**Flood Control Project Maintenance
Levee Inspections**

Maintenance Issue Types Only, Levee Inspection Report By Mile - Spring 2015

Reclamation District No. 0765 Glide

Waterway	Bank	Unit Miles	Inspection Start/End	Inspector
Unit No. 01 Sacramento River	Right	1.72	04/23/2015 04/23/2015	Richard Willoughby

Photo 2 of 2 : SP_2015_RD0765_211_6_20150309_00008.jpg

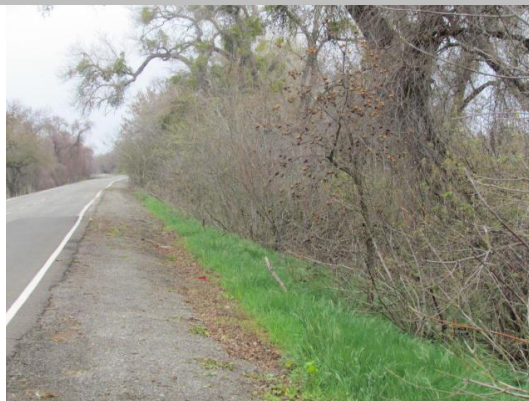
LM Start	0.98	Rating **	A/W	Issue No.	6
LM End	1.14	Issue Type +	Ma	Location *	WS
Category	Earthen Levee			GPS Latitude/Longitude	
				Start	End
Item	Trim / Thin Trees			38.489664 °	38.487617 °
				-121.555370 °	-121.554200 °
DWR ID	DWR_RD0765_01_f_2012_6				
Action/Comments					
Trim trees to at least five feet above ground level.

Looking north (upstream) at untrimmed trees on waterward slope.

Photo 1 of 4 : SP_2015_RD0765_211_37_20150309_00042.jpg

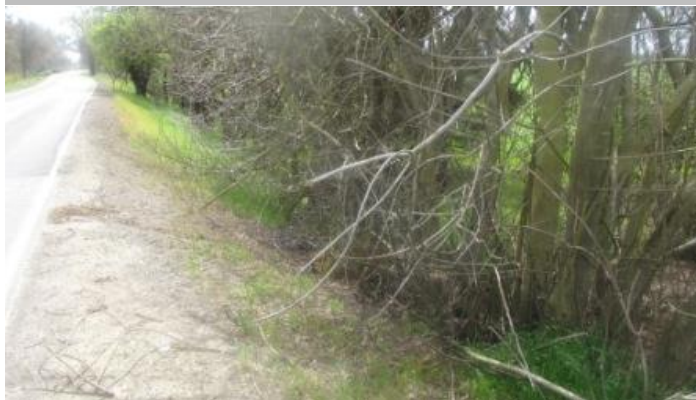
LM Start	1.07	Rating **	A/W	Issue No.	37
LM End	1.07	Issue Type +	Ma	Location *	LS
Category	Earthen Levee			GPS Latitude/Longitude	
				Start	End
Item	Trim / Thin Trees			38.488503 °	38.488503 °
				-121.554757 °	-121.554757 °
DWR ID	DWR_RD0765_01_s_2012_37				
Action/Comments					
Trim and thin trees to allow visibility of the ground and room to flood fight.

Looking downstream (south) at trees on landside slope & toe from 2010 fall inspection.

Photo 2 of 4 : SP_2015_RD0765_211_37_20150309_00043.jpg

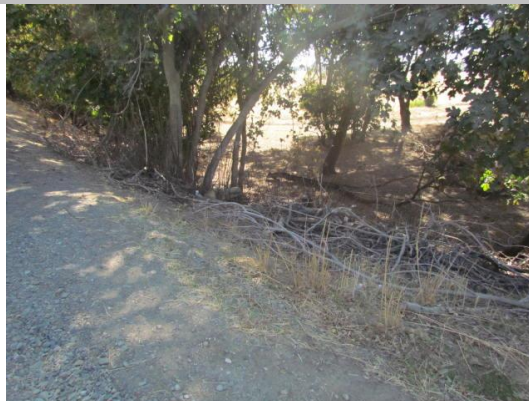
LM Start	1.07	Rating **	A/W	Issue No.	37 (cont)
LM End	1.07	Issue Type +	Ma	Location *	LS

Looking southwest at trees on landward slope.

Photo 2 of 2 : SP_2015_RD0765_211_52_20150309_00054.jpg

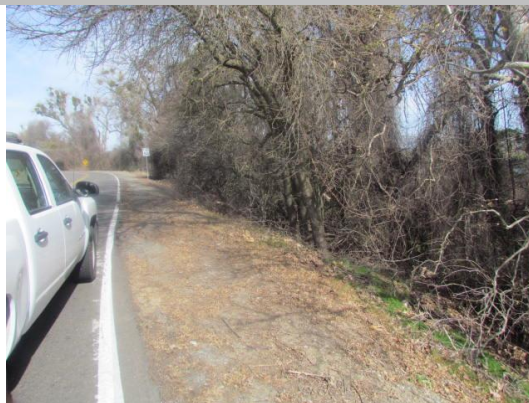
LM Start	1.69	Rating **	A/W	Issue No.	52 (cont)
LM End	1.72	Issue Type +	Ma	Location *	WS

Looking north (upstream) at dense trees on landside slope.
